**FINAL REPORT 10CFR PART 21
REPORTING OF DEFECTS AND NON-COMPLIANCE**

PREPARED BY: Ed Grandusky
TITLE: Nuclear Product Engr.
DATED: 8/24/95
TIME: 4:30 AM/PM
PART NAME: Nut, Lock-Flexloc Reg Hgt.

File No.: F-36674 A/B/C/D
Serial No.: T-36674 A/B/C/D
Type: GS-2N
Ref.: N/A
D-R Part No.: 75233A06
D-R Dwg. No.: 75233A
Rev. Level: D

TYPICAL ASSEMBLY

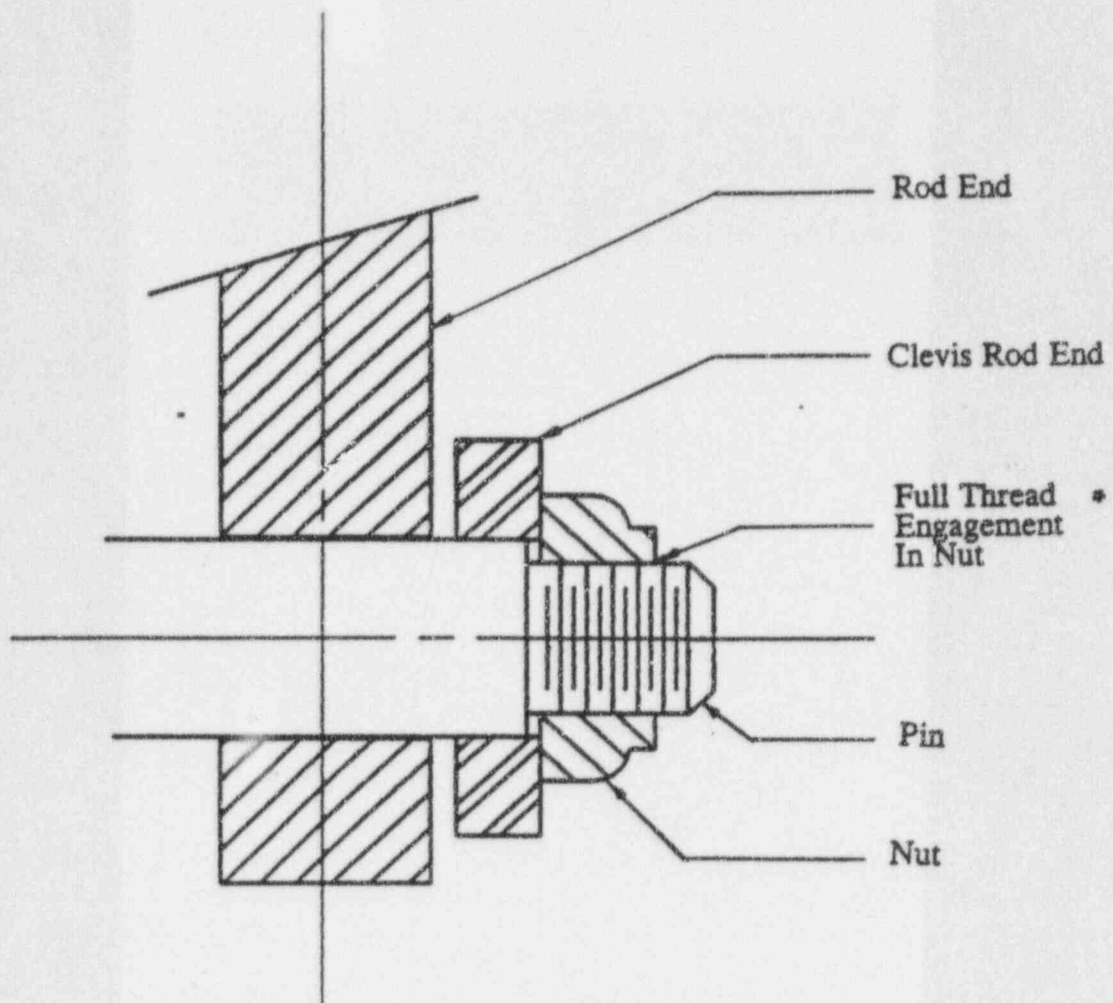
Regular locknut, SPS-Flexloc no. 21FA616, D-R p/n 75233A06 may be installed on governor valve linkages where the thinner locknut, SPS-Flexloc no. 21FK616, D-R p/n 75232A06 is required.

Inadequate thread engagement in the thicker locknut may result in linkage separation if the nut loosens from vibration and spins off. This will result in loss of turbine control capability.

Inspect all applications of locknuts on the control linkage for full thread engagement in locknut.

*** All threads in the locknut must be engaged by the threads on the pin. Amount of exposed threads will vary with application.**
